Technical Service Information

FORD/MAZDA CD4E

PERSISTENT GEAR RATIO ERROR OR TCC SLIP CODES

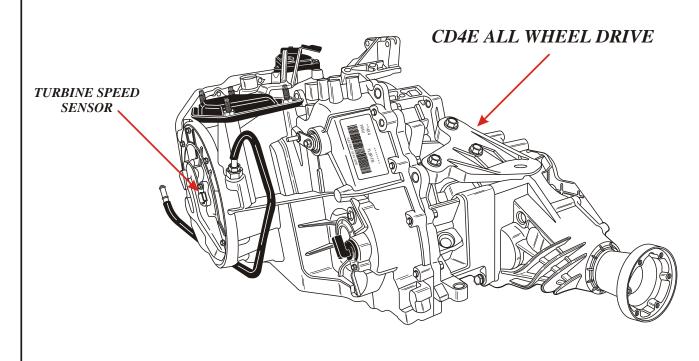
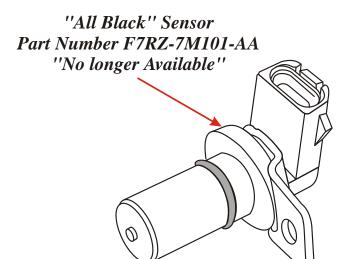
The cause, believe it or not, is the replacement Turbine Speed Sensor. The replacement TSS was redesigned and has an *enclosed* pickup as seen in Figure 2. The previous design TSS has an *exposed* pickup also seen in Figure 2.

It seems, when the pickup was enclosed, the air gap between the TSS and the reverse clutch hub was increased. When the signal was checked and compared to the previous sensor signal, the new sensor signal exhibited a voltage difference but, when checked with an oscilloscope the previous sensor puts out a wider pattern than the current design sensor which means, the computer has more time to read the signal with the previous design sensor. In other words, with the current design turbine sensor, the computer does not have enough time to read the signal and may miss alternate signal pulses which causes the above complaint, on some models only.

CORRECTION: Ford Motor Co. has now released a new design white TSS with a "green" connector that is to be used on 1994-1997 Probe vehicles, as shown in Figure 2. The new design white TSS with the "black" connector is to be used on "All Other" models using the CD4E transaxle, as shown in Figure 2. Install the proper TSS depending on the model that you are working on and service part numbers are shown below.

Turbine Shaft Sensor, 1994-1997 Probe Only, Green Connector F7RZ-7M101-KA

White With "Black" Connector Part Number 1S7Z-7M101-KA "All Other" Models
